U.S. Department of Transportation
 National Highway Traffic Safety Administration
 Office of Defects Investigation
 NVS-210, 400 7th Street SW
 Washington, DC 20590

Enclosed, for your examination and analysis, is the clutch pedal assembly of my 1996 Volkswagen Passat that failed last month (April 2005) on a morning commute. I'm submitting this part and this information because I feel that the failure was caused by a design and/or manufacturing defect and that other owners may be at risk of experiencing the same safety-related failure.

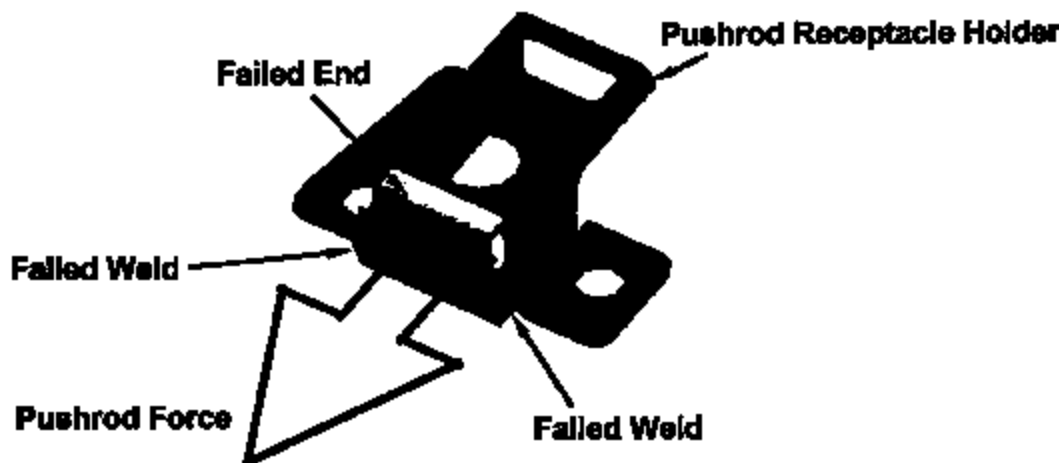
Failed Part Description: Near the pivot end of the enclosed clutch pedal assembly, you'll see a formed sheet metal box I'm calling the "pushrod receptacle holder" (see Figure below). The spherical end of the clutch pushrod operates on a plastic receptacle (not shown) which, in turn, pushes against the back end of the holder (the yellow end in the Figure) when the pedal is pressed. Because the holder is a thin gage, bent-up sheet design, most of the pushrod force is reacted by the two small welds (shown in red in the Figure) that are intended to secure the yellow end.

Failure Analysis: If you examine the failed welds closely you'll see (even with the naked eye) that there is very little weld penetration evident. This pedal is poorly designed because it's too dependent on weld process quality. I assume that Volkswagen engineers evaluated and tested this design before they approved it for production, but in my opinion (as a mechanical engineer) it has the following multiple defects: 1) The design relies on the strength of welds rather than on the strength of parent material (as in a conventional clevis/shear pin design, for example). 2) The critical welds are cheaply small and

therefore, more highly loaded than necessary. 3) The critical welds are loaded in fatigue-vulnerable bending rather than in shear. 4) There is no provision for a graceful failure as might be provided by using heavier gage "holder" material, for example.

As long as the pedal manufacturing process creates an adequate weld on *both* sides of the "holder", the clutch pedal is functional. But, in my opinion, this design is too marginal for use on a safety-related part and my unfortunate experience proves the point.

Unfortunately, the dealer-installed replacement clutch pedal is of the same poor design. I'm not taking the chance that the welds on this pedal assembly are of equally poor quality. I've designed and installed an angle bracket that will prevent the "holder" from failing in the future. I may not own this car nine years from now, but if it's still on the road, at least the clutch pedal will work reliably.
